**REMARKS**

**Amendments to the Drawings**

Annotated Marked-up drawings

FIG. 9A  
Prior Art

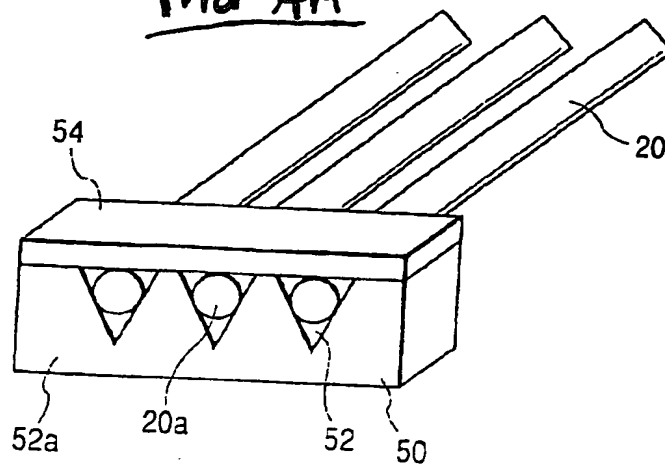
15 Figs. 9A, 9B, 10 and 11 have been amended to add the label “Prior Art” pursuant to the requirement in the Office Action.

In response to the Examiner's requirement, Figs. 9A, 9B, 10 and 11 have been labeled "Prior Art". Annotated sheets with the addition in red and replacement sheets are  
5 attached to the end of this amendment.
